CAP MEETING – 8 NOVEMBER 2023

ITEM 8.1

| DEVELOPMENT NO.: | 22041947 |
| NATURE OF DEVELOPMENT: | Change of use to include brewery (light industry) within part of store building (producing 44,000L per annum) & construction of mezzanine within the store building for sale & tasting of beer with associated car parking |

| DRAWING TITLE | |
|-----------------------|----------------|
| SITE PLAN | |

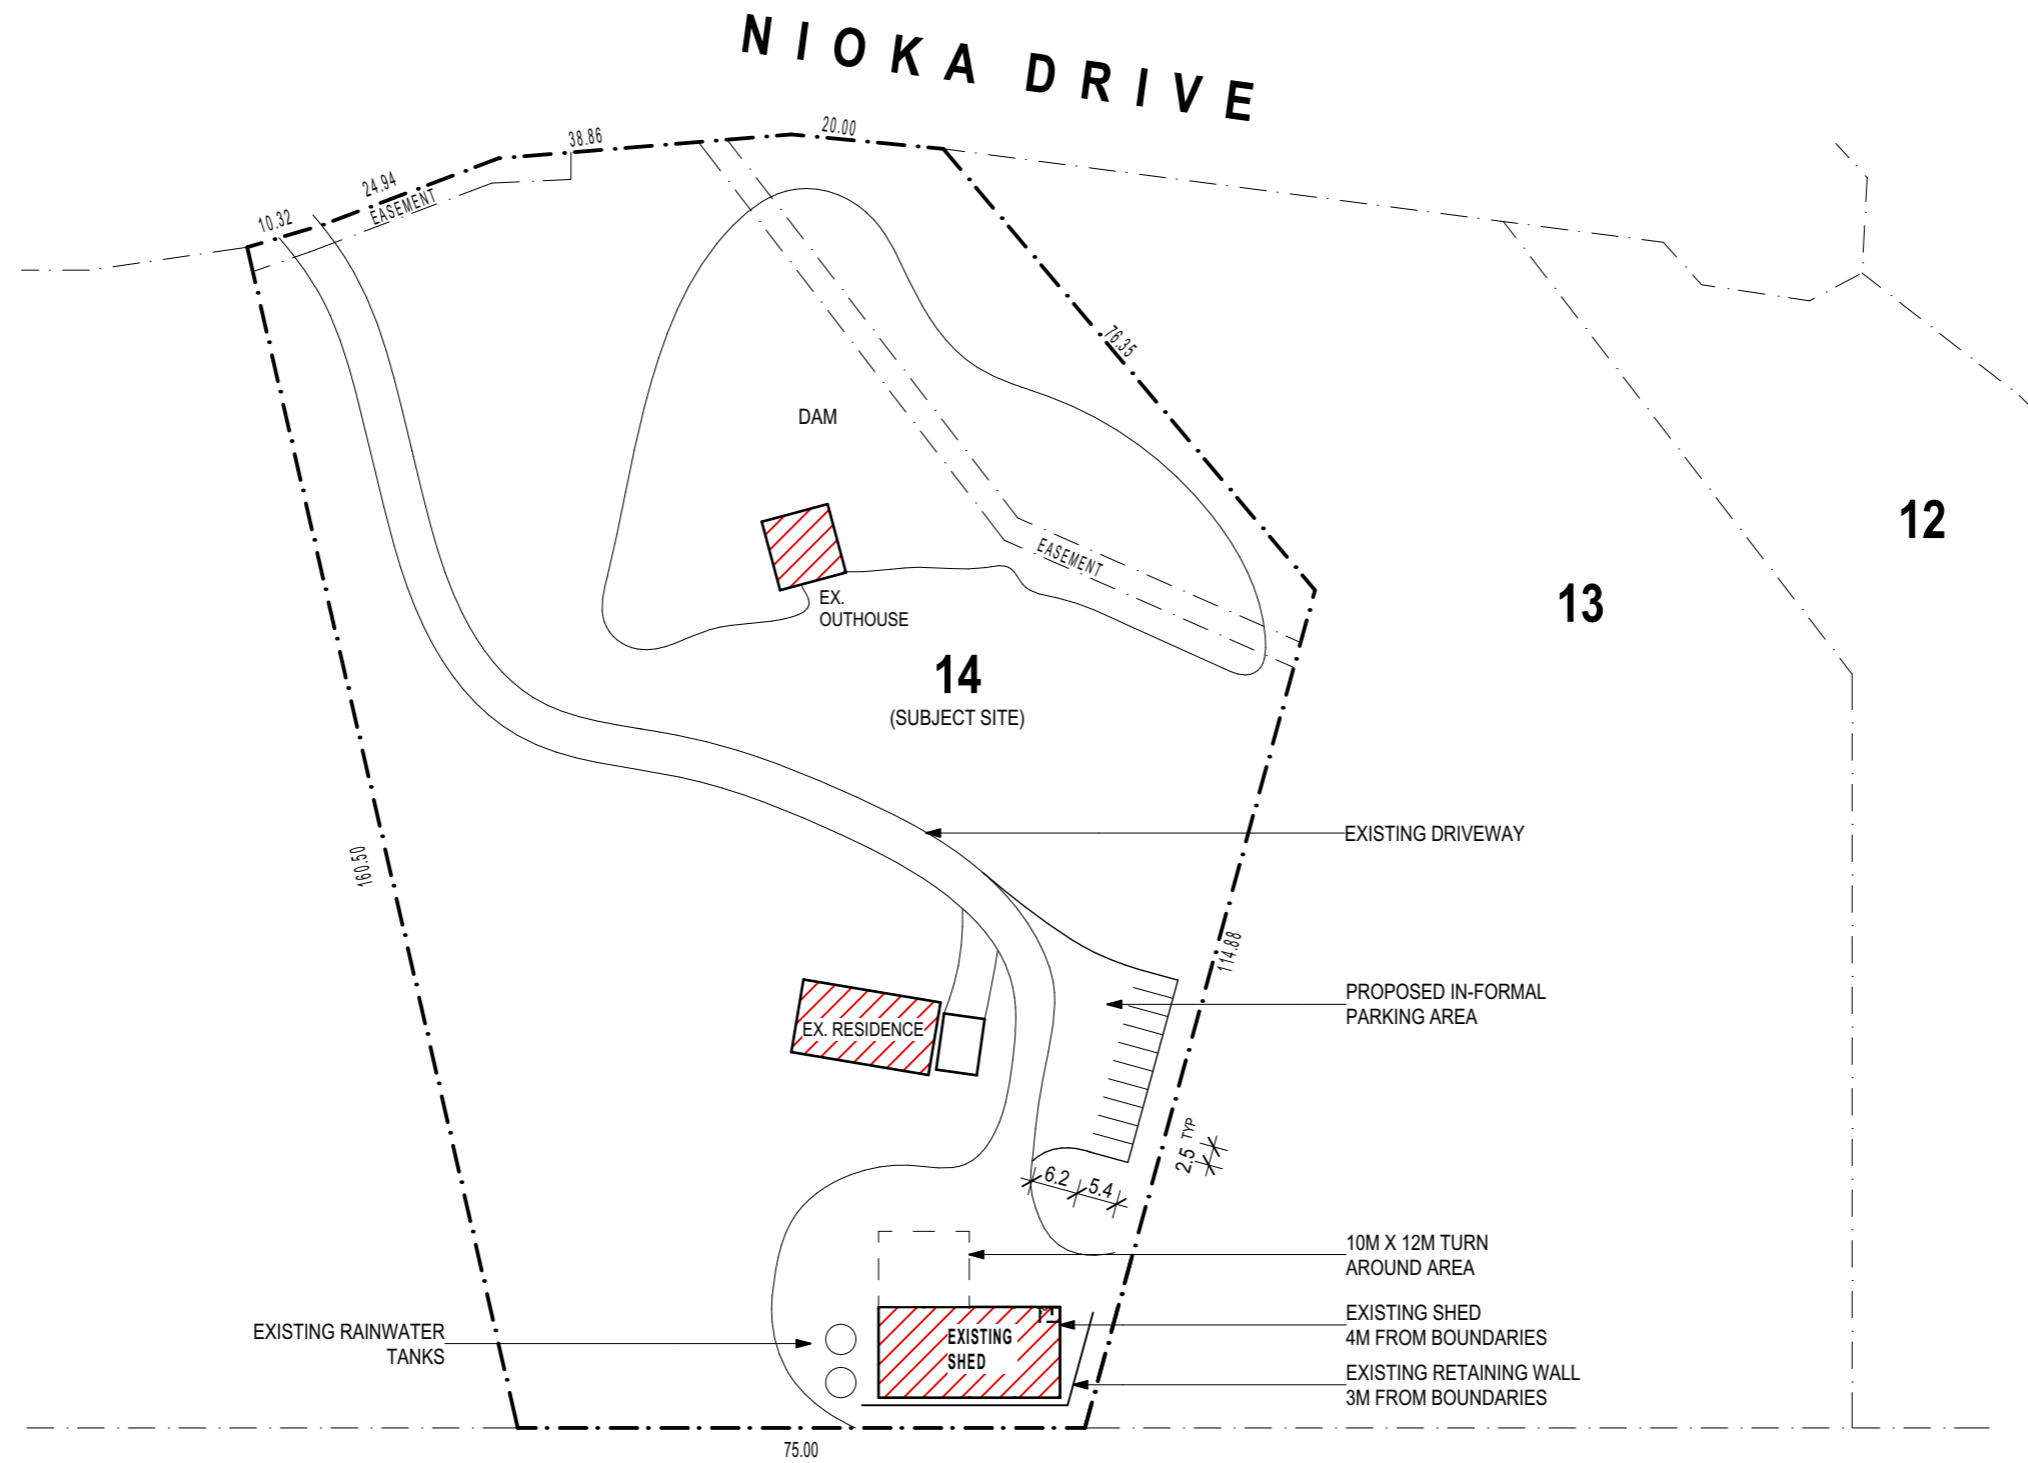
- Update the site plan. All buildings are highlighted in the red hatching. Clearly mark in some other way the brewery building.

Updated plans attached.

| DRAWING TITLE GROUND FLOOR PLAN | |

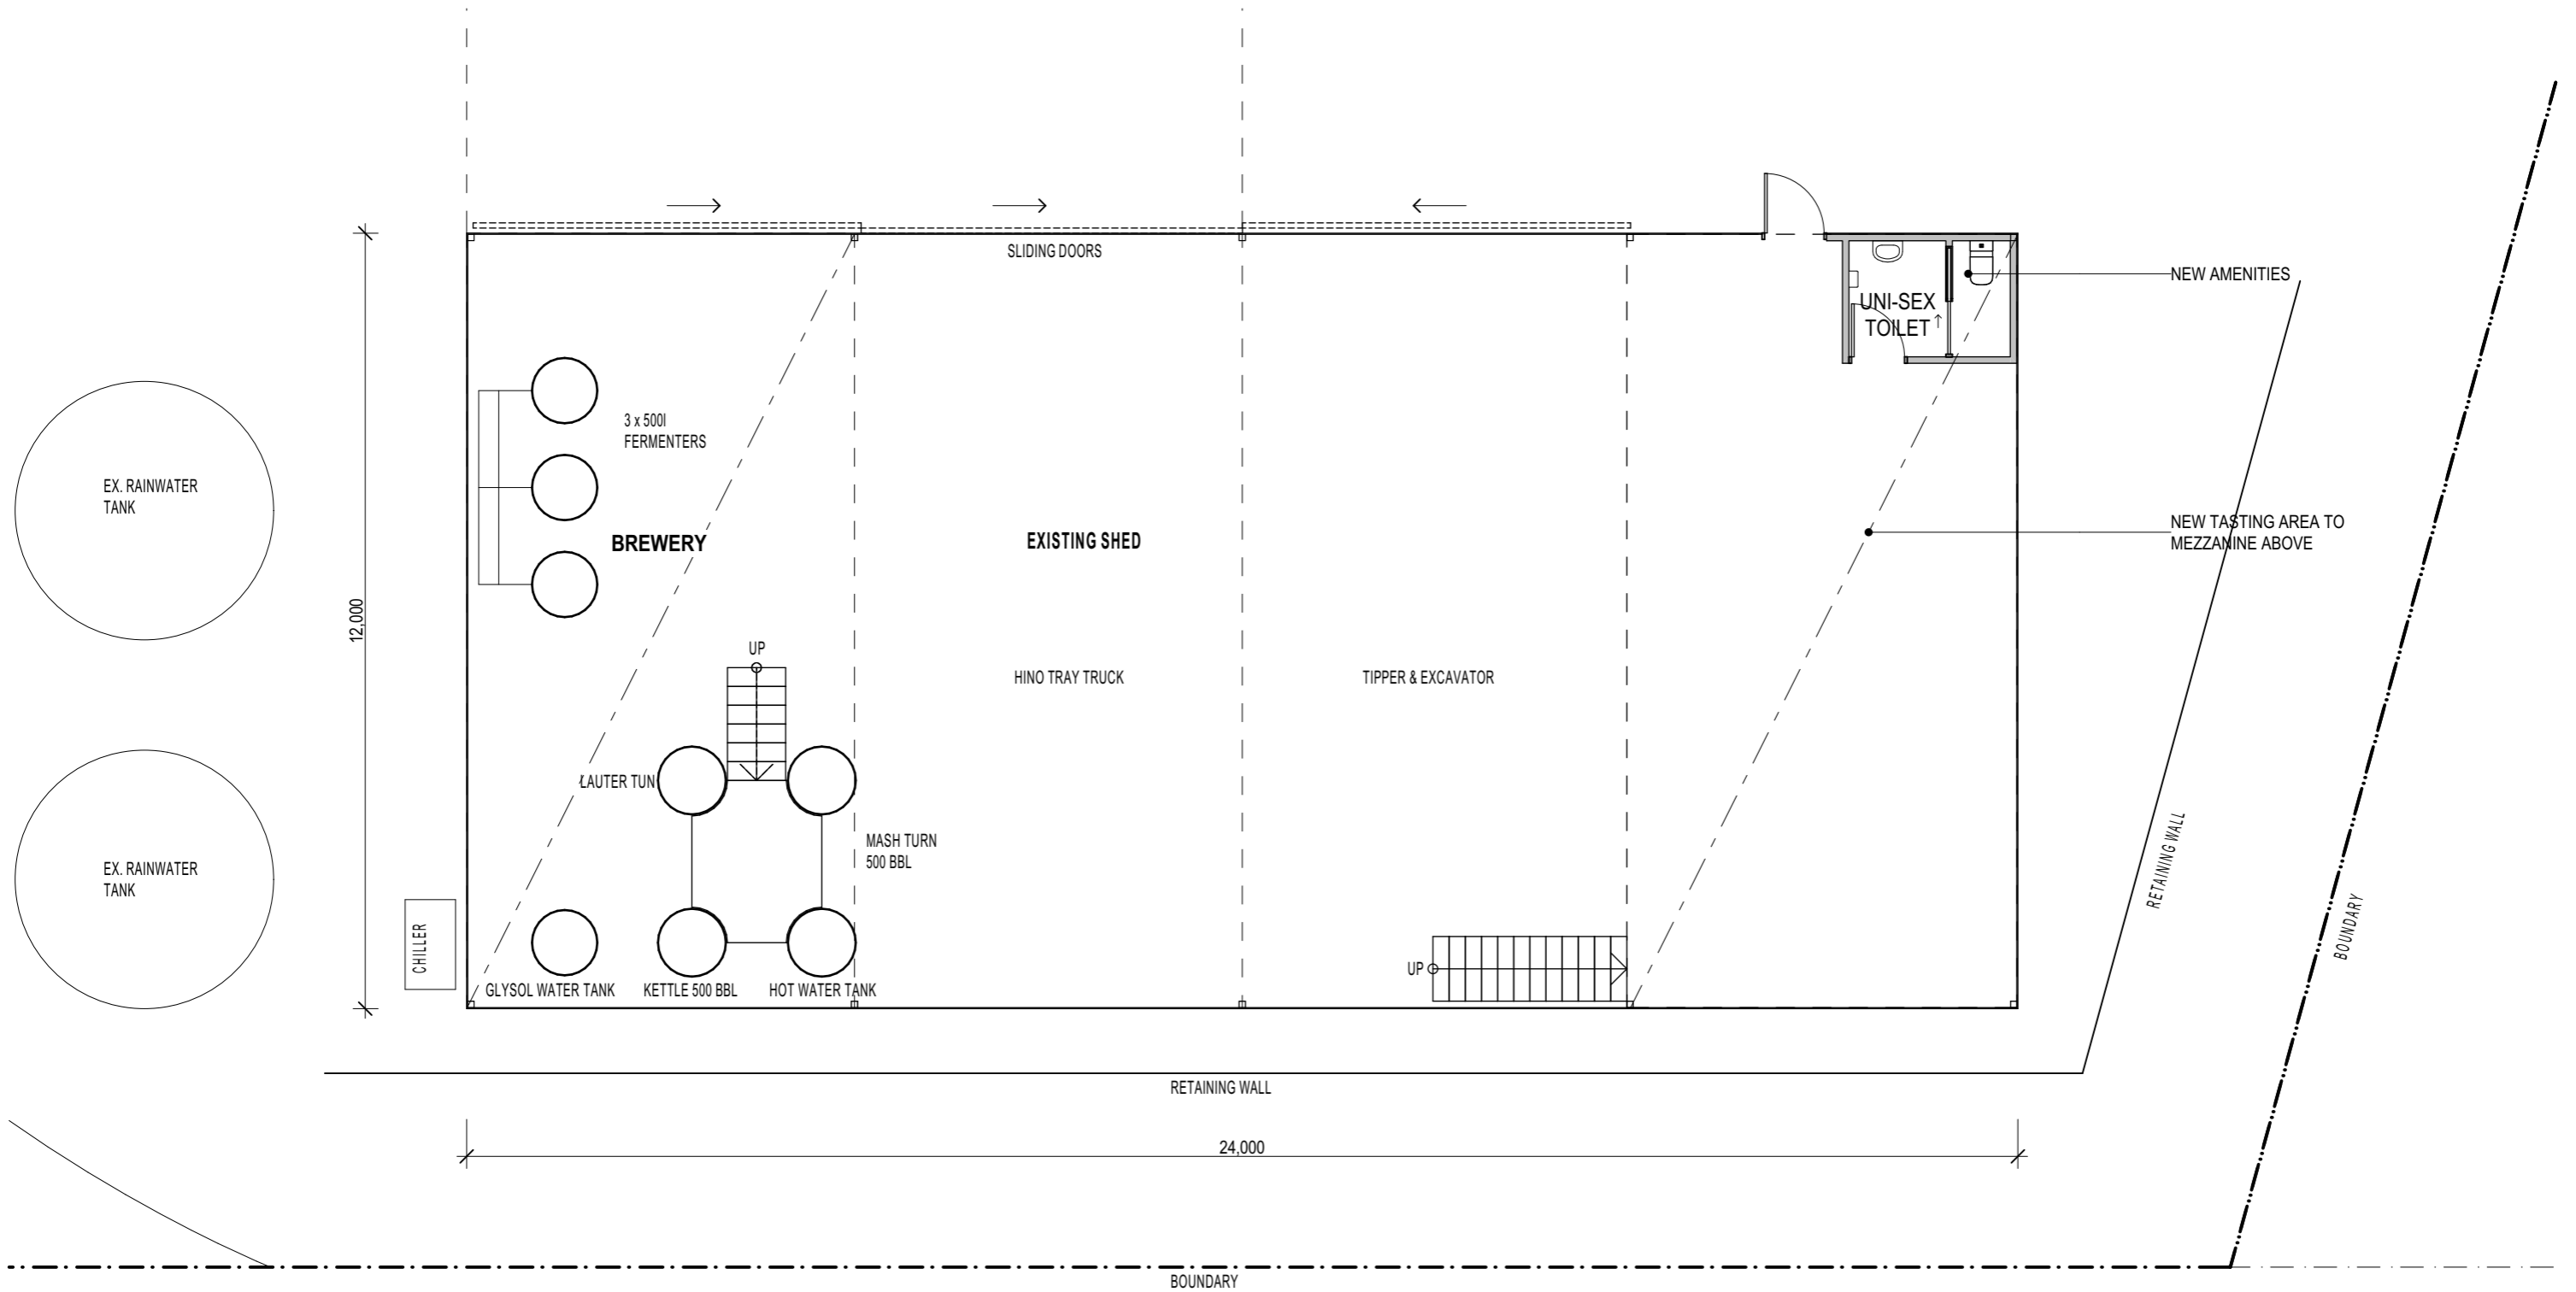
- Show the location of all brewing equipment, including bottling plant and waste storage areas/devices.

- From the noise assessment report 2x chillers are noted and multiple fans. The floor plan shows only one chiller on the western side and the written document speaks to one fan. Clarify.

UPPER MEZZANINE

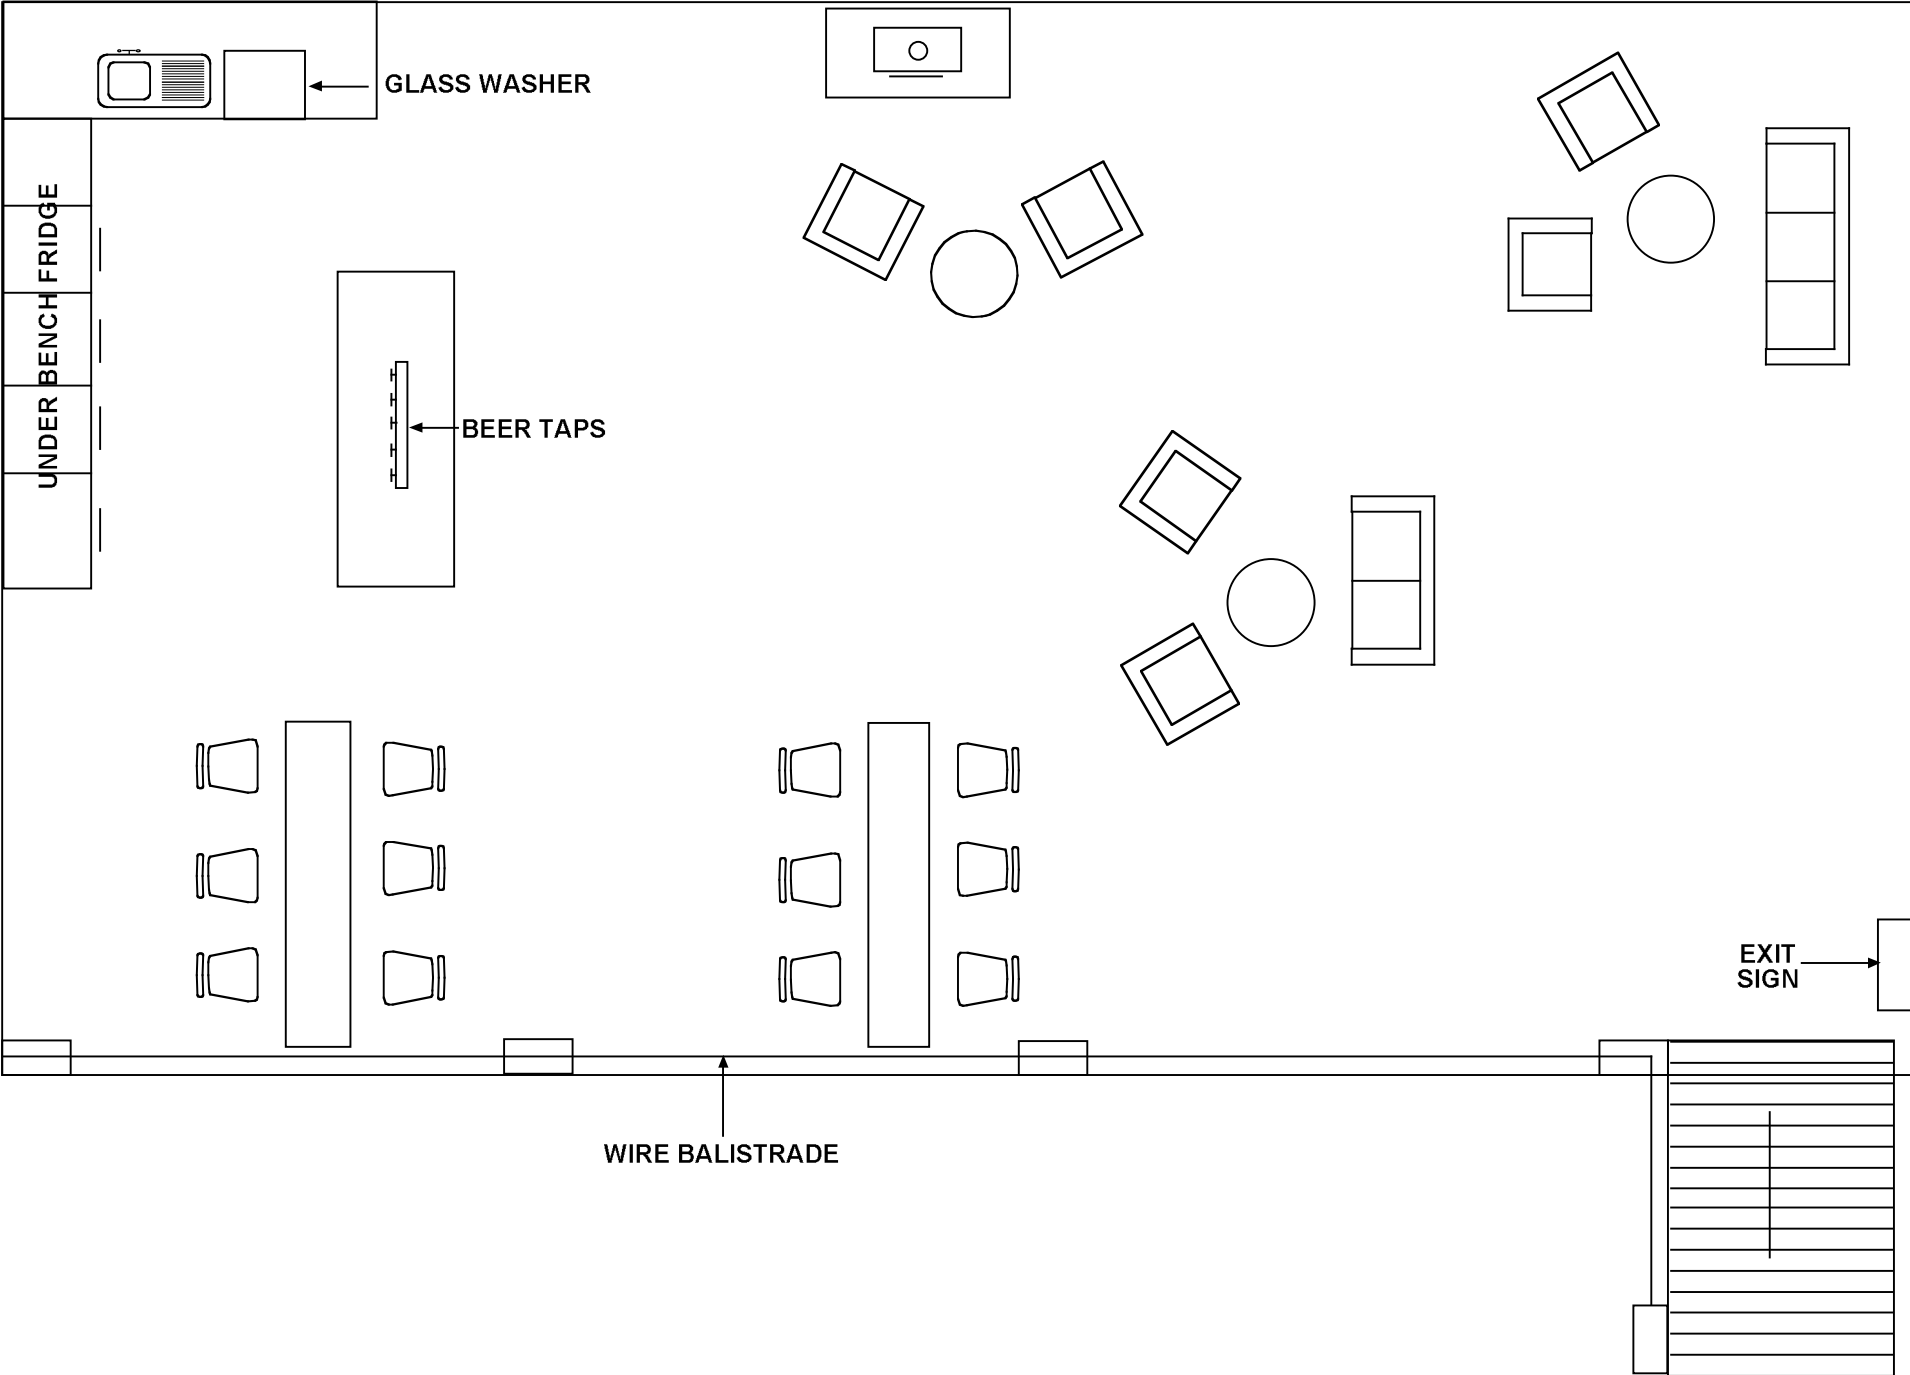
- Provide a floor plan of the layout of the mezzanine. Wet areas on this level will require wastewater approval too. Previously requested.
